RECEIPT DATE: 6-13-16 **ONSITE SEWAGE DISPOSAL SYSTEM** P 568756

Re: Walnut Creek, Lot 82 12237 Hayland Farm Way, BAT Plan

RE: BAT Plan 12237 Hayland Farm Way

BAT INSTALLATION SITE PLAN
WALNUT CREEK
LOT 82
12237 HAYLAND FARM WAY
PHASE THREE

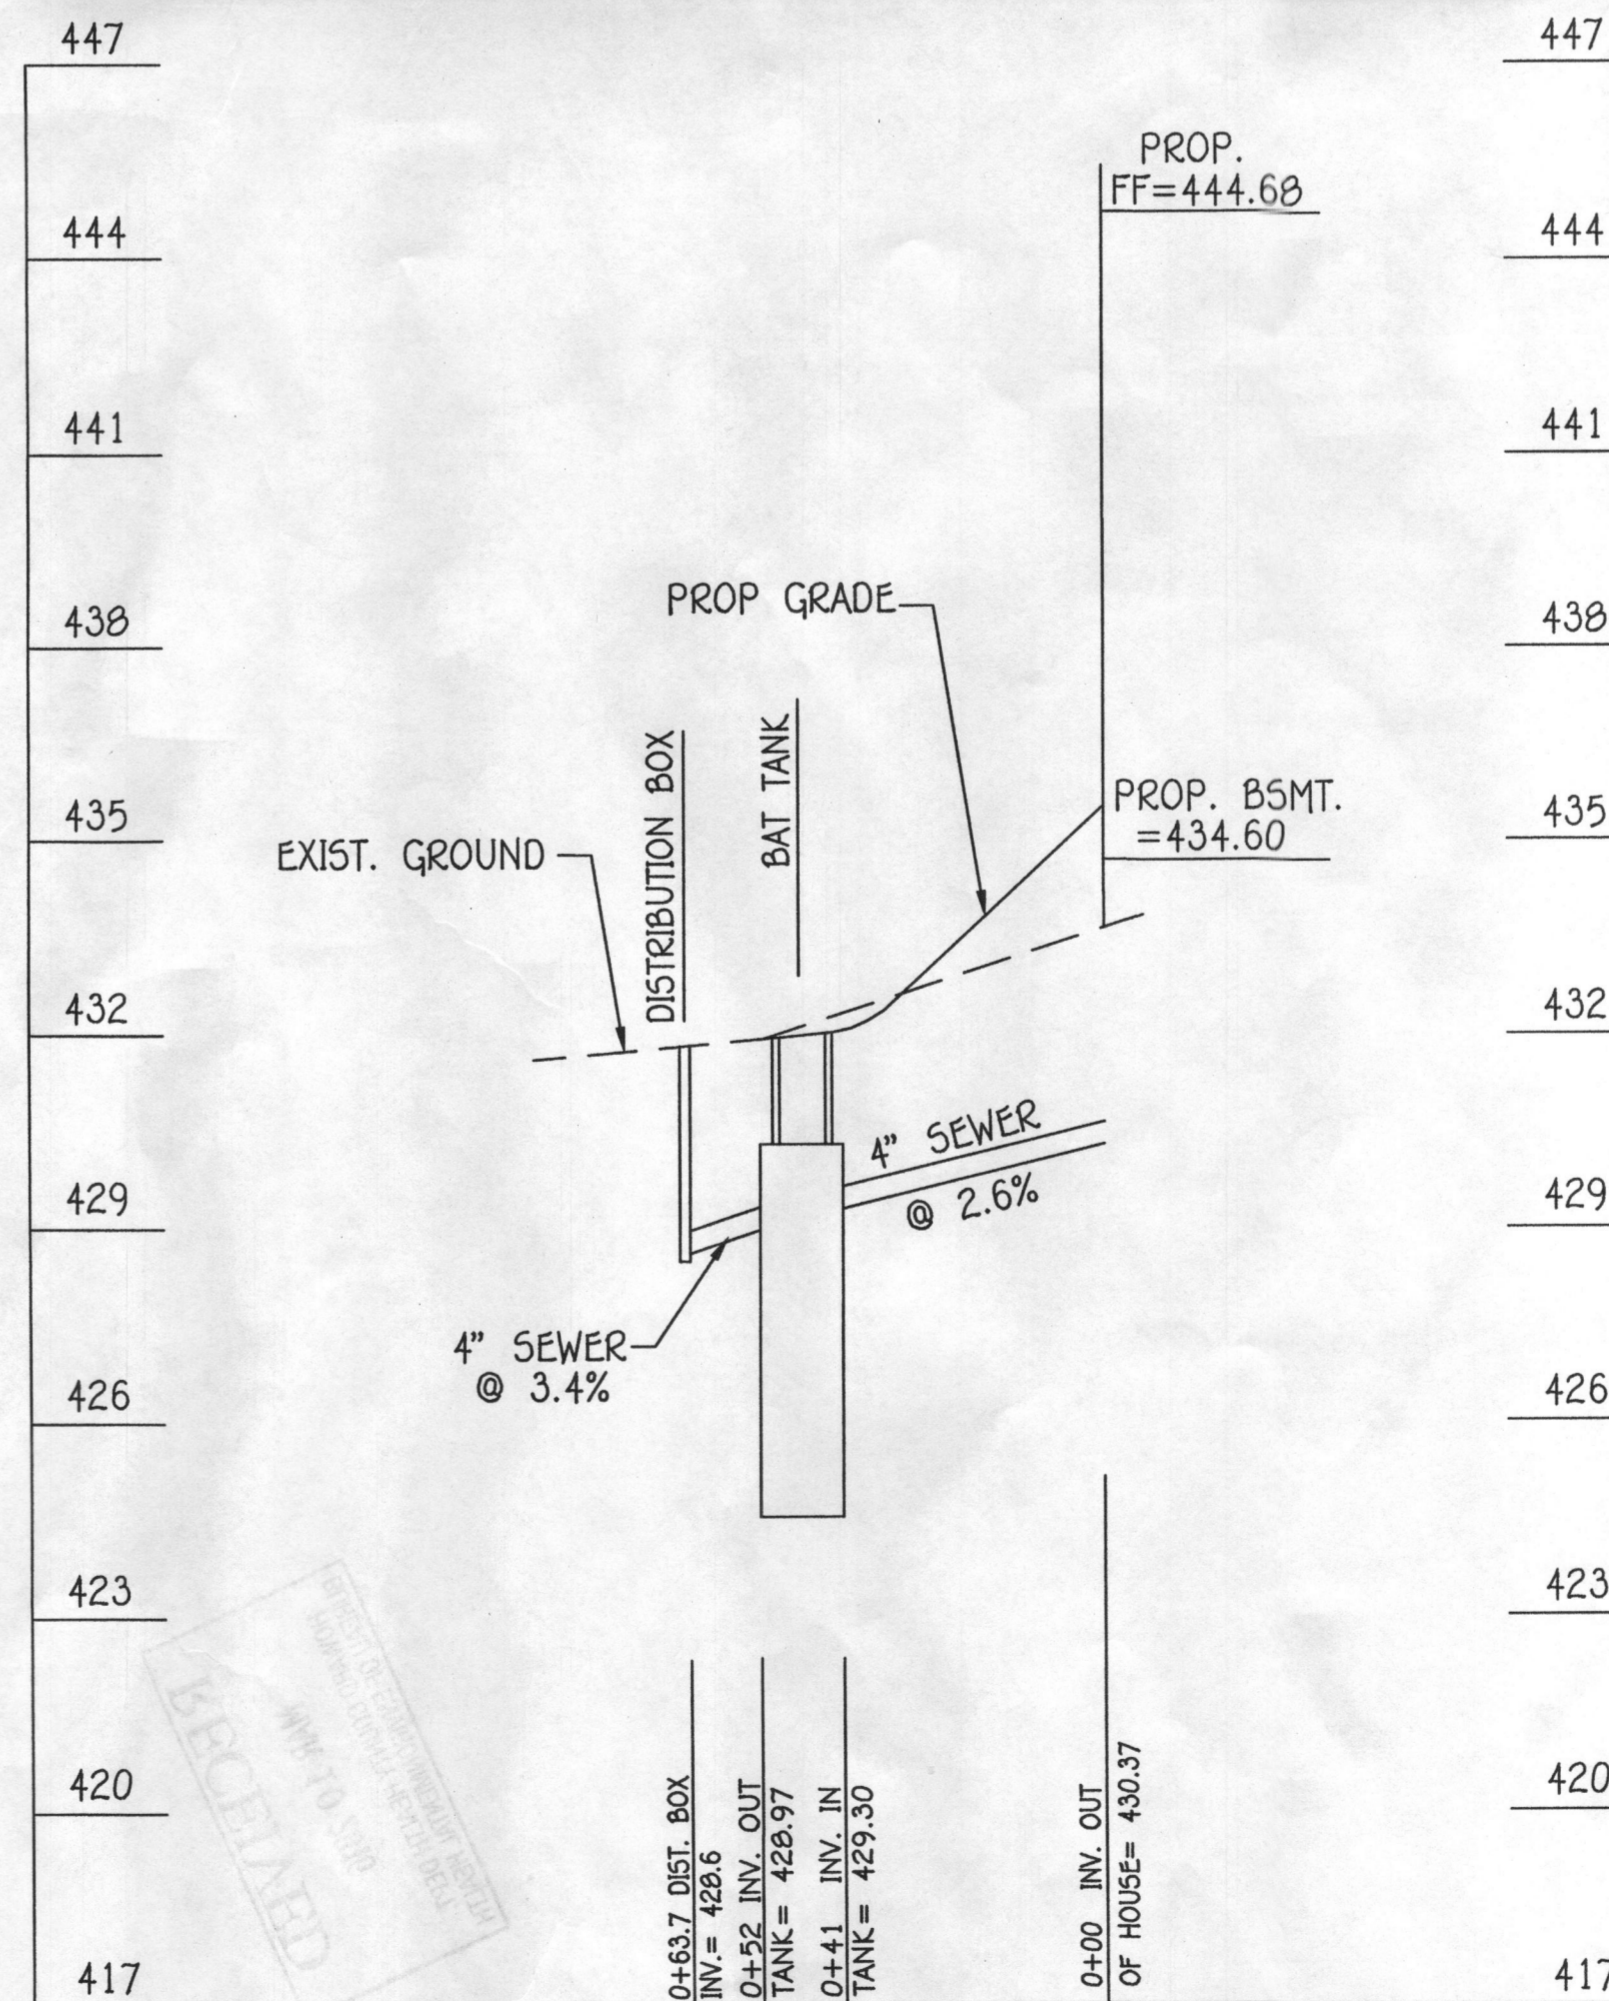
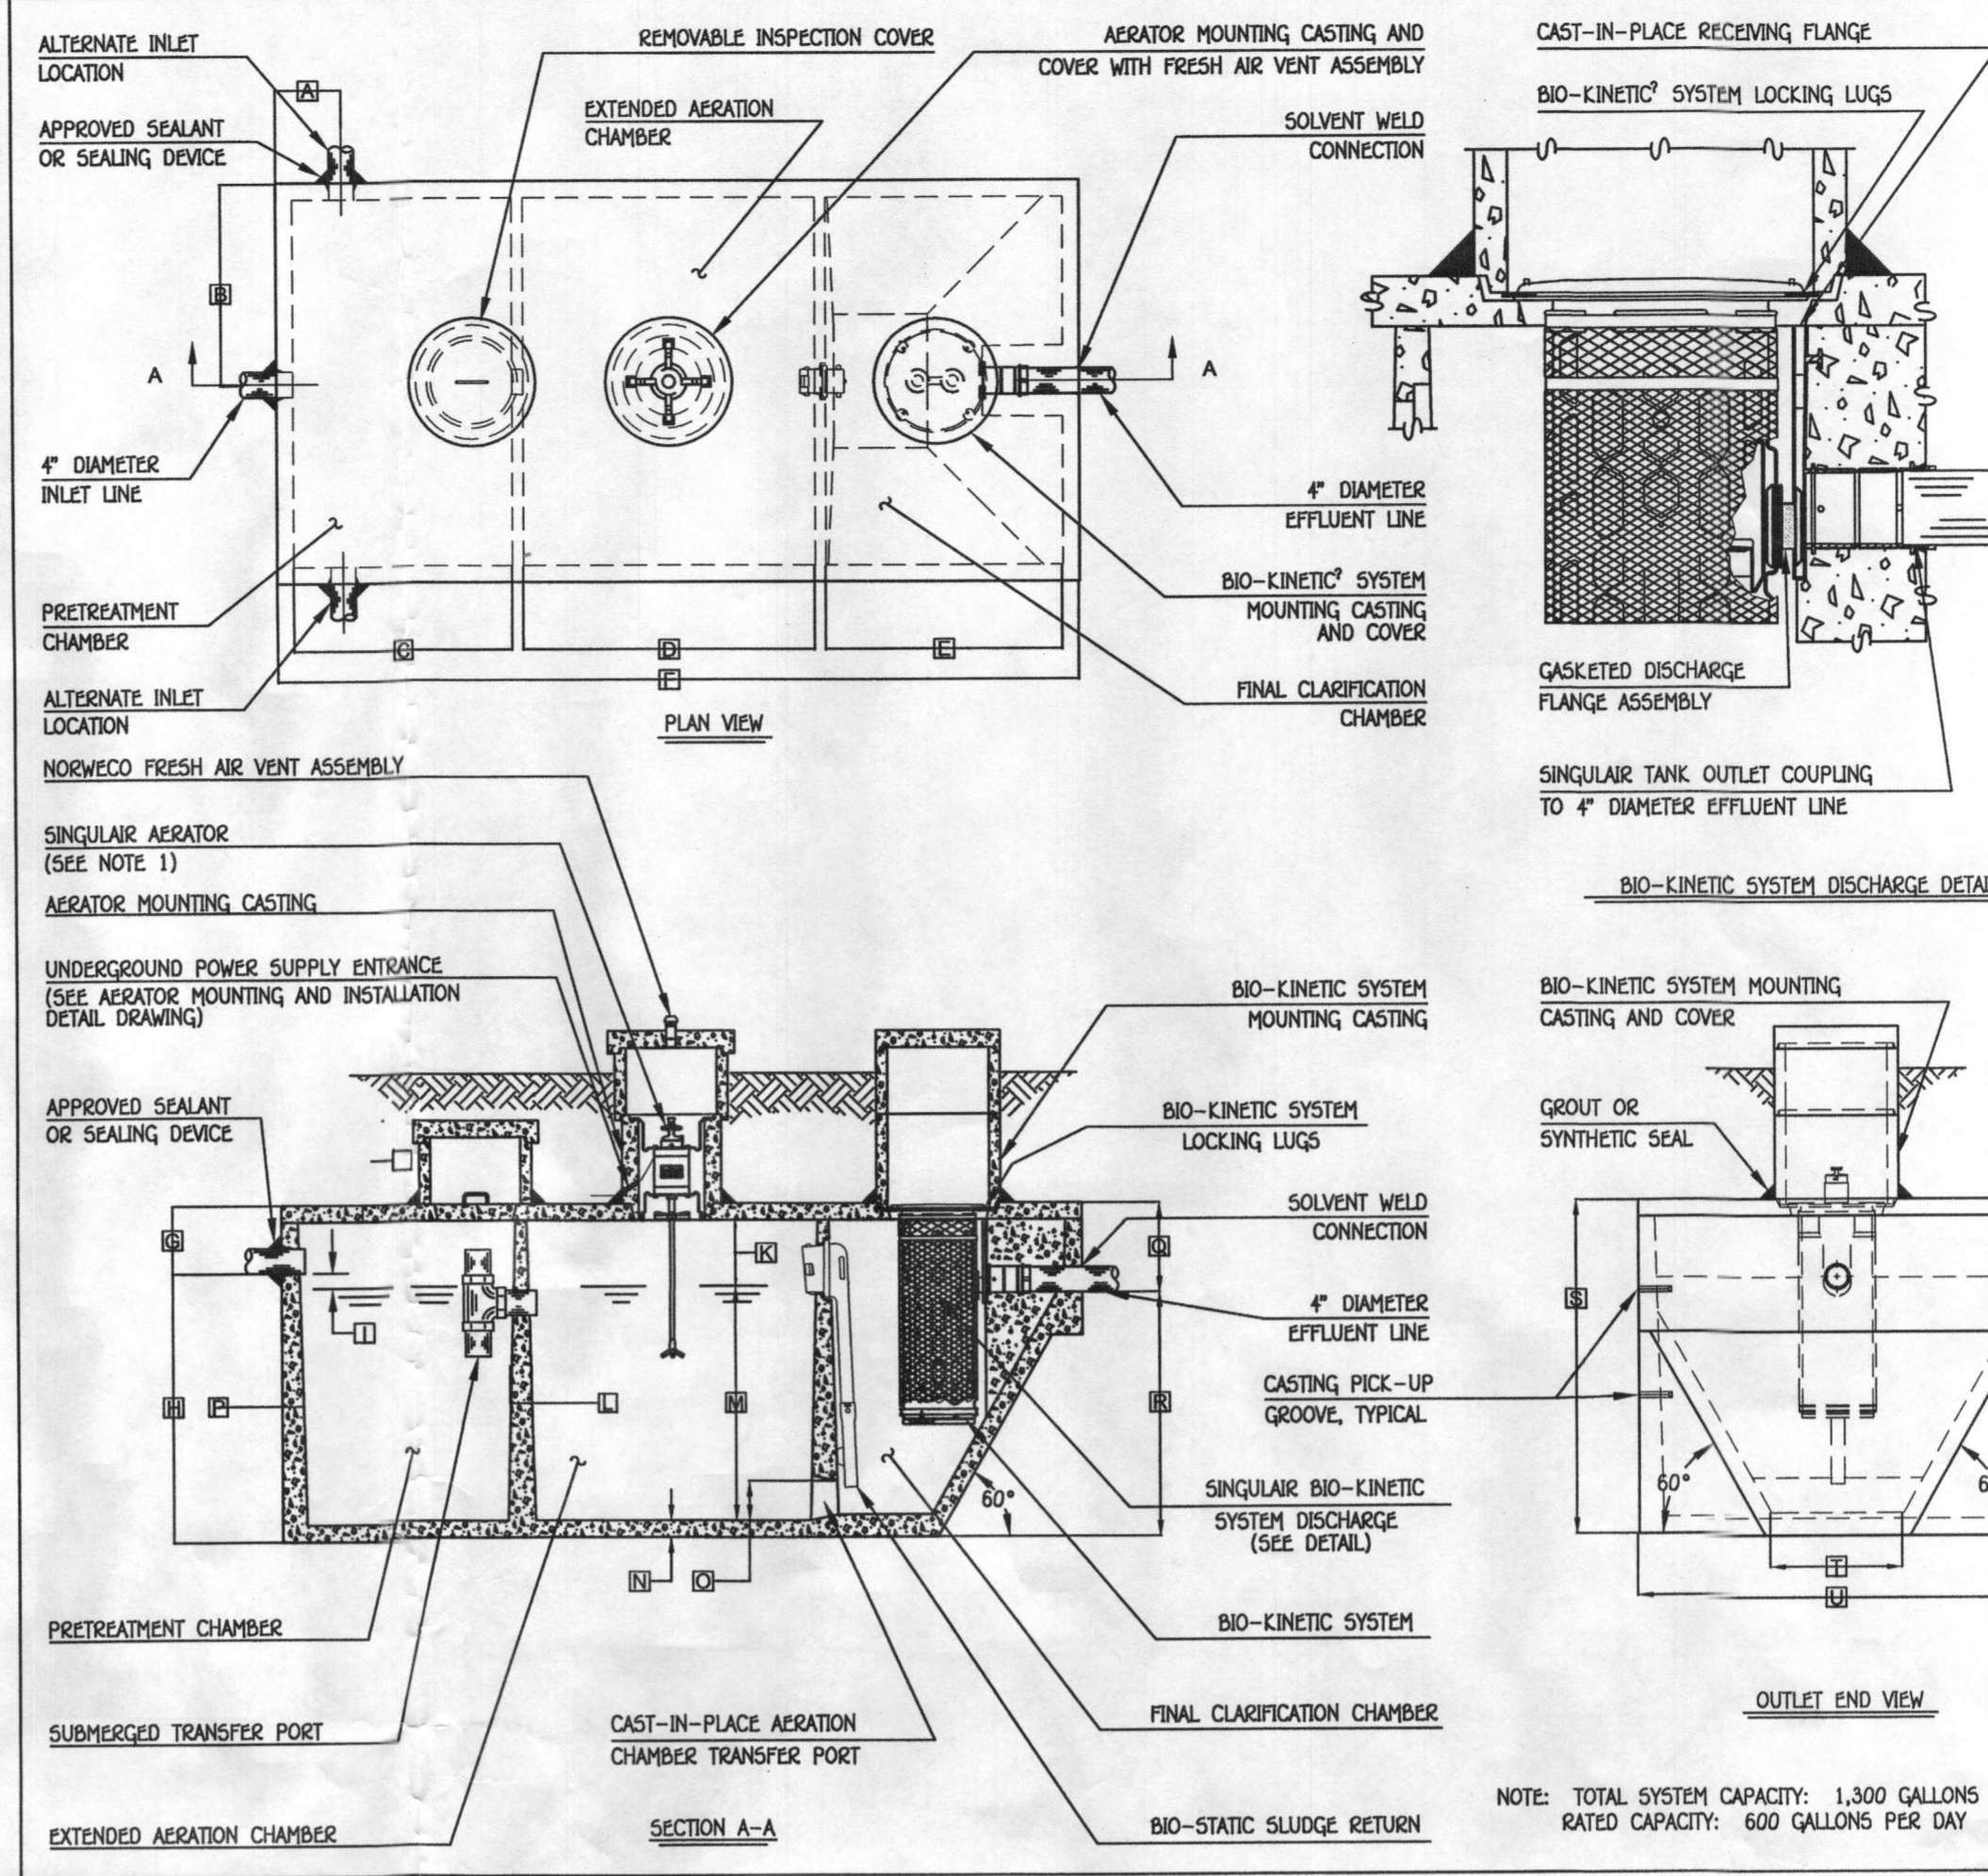
I've reviewed the revised BAT plan for Walnut Creek lot 82 and the well certification statement in BAT note 12 still references the wrong well tag number. Please correct and resubmit. Thanks
Jeff

- The alternate well site is located less than 10 feet from the driveway. The well site must be relocated via a revised perc certification plan or bollards or landscape protection such as large rocks must be shown on the plan to protect the site.
- BAT note #12 references a well tag number different from the actual well on the lot.
- The calculations for the trench requirement use 4 feet of available sidewall where only 3 feet area available. While the trench depth is from 4-8', the sidewall doesn't start until 5' depth. As a result, the total trench length required is more than what is shown on the plan.

I have reviewed the Floorplans for WC lot 82. We count 4 bedrooms on the 2nd floor and none on the other floors. However, the rough in for a full bath in the unfinished basement makes it very likely for a room to be considered a bedroom when the basement gets finished in the future. We strongly recommend upsizing the system for at least 5 bedrooms to account for that. When we get a building permit, we will be sending the builder a memo with this message. You may want to confer with them to see if they choose to upgrade or stay with a 4 bedroom design. If they choose to stay at 4 bedrooms, we will retain the memo in our file to use when the basement is to be finished. Thanks

We are confused by this comment. We received comments from you (copy attached), which we are addressing. The design is for 5 bedrooms on the BAT plan. The trench computations will be revised with the adjusted side wall reduction.

NOTE: BOLLARDS OR LARGE ROCKS MUST BE PROVIDED FOR PROTECTION OF ALTERNATIVE WELL SITE IF THIS WELL IS EVER INSTALLED.

- PROP. INVERT AT FOUNDATION WALL: 430.30
1. NORWECO TITLP-500 GPD (MAX. NO. BDRMS.=6)
EX. GRADE OVER TANK: 432.1
PROP. GRADE OVER TANK: 432.0
INVERT IN: 429.30
INVERT OUT: 428.97
TOP OF TANK ELEV.: 430.30
2. DISTRIBUTION BOX:
EX. GRADE: 432.4
PROP. GRADE: 432.4
INVERT IN: 428.6
3. TRENCH DESIGN (INITIAL SYSTEM):
(5 BDRM X 150 GPD/BDRM= 750 GPD)
750 / 0.8 APP. RATE = 937.5 SF
USE 3' WIDE TRENCH AND 10' MIN. SPACING BETWEEN TRENCH EDGES.
937.5 SF / 3' WIDTH = 312.5 L.F. X 0.5 = 156.3 L.F. MIN. TRENCH
USE 2- 78.5' LONG TRENCHES = 157 L.F.
4. TRENCH DESIGN (1ST REPLACEMENT SYSTEM):
(5 BDRM X 150 GPD/BDRM= 750 GPD)
750 / 0.8 APP. RATE = 937.5 SF
USE 3' WIDE TRENCH AND 10' MIN. SPACING BETWEEN TRENCH EDGES.
937.5 SF / 3' WIDTH = 312.5 L.F. X 0.5 = 156.3 L.F. MIN. TRENCH
USE 2- 78.5' LONG TRENCHES = 157 L.F.

- IF THERE IS EXCESSIVE RESISTANCE TO THE AERATOR MOTOR, AN ALARM WILL BE VISIBLE AND AUDIBLE. SEE MANUFACTURER SPECS FOR ADDITIONAL INFORMATION.
- THE EXISTING WELL, TAG NO. HO-95-2599, HAS BEEN FIELD LOCATED AND IS ACCURATELY SHOWN.
